Model: Iris/Lilac/Cattleya Platen Cover Date					1	No.: MA749001			
Modified Article: Platen Cover Hinge					Prepared by: M. Tsuyuki				
From: Technical Services Dept., GTS Division									
Reason for	☐ Parts catalog correction	☐ Vendor ch		ange	☐ To n	neet standards			
Modification:	odification:		∑ To improve reliability		(	)			
	☐ Part standardization	☐ Other

## **M**odification **B**ulletin

## 1. Platen Cover Type 100 (A749)

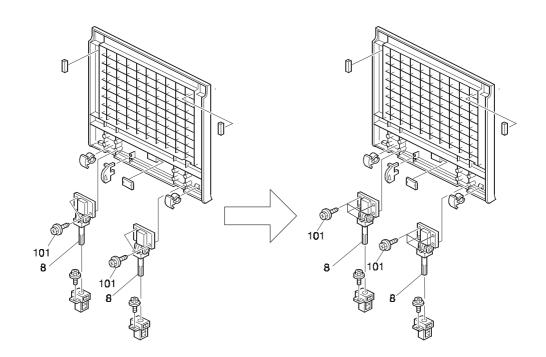
Old part	New part	Description	Q'ty	Int	Page	Index	Note
number	number						
A7491021	A7491121	Platen Cover Hinge	2	X/O	3	8	
04504016B		Tapping Screw – M4x16	4→8	X/O	3	101	
	04504025H	Tapping Screw – M4x25

To prevent the mounting position of the platen cover hinge from being damaged, the platen cover has been modified and the number of screws which mount the hinge on the platen cover changed from two to four.

This modification has been done from June 2000 production.

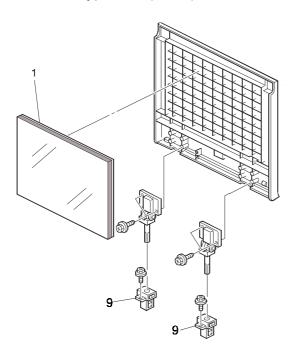
To ensure that the original is flat and secure against the exposure glass, the Platen Cover Cushion has been thickened and the height of the Hinge Holder has been increased.

Old part	New part	Description	Q'ty	Int	Page	Index	Note
number	number						
A7491007	A7491107	Platen Cover Cushion	1	X/X	3	1	*
A7491035	A7491135	Hinge Holder	2	X/X	3	9	*

\*Note: The two new parts should be replaced together as a set.
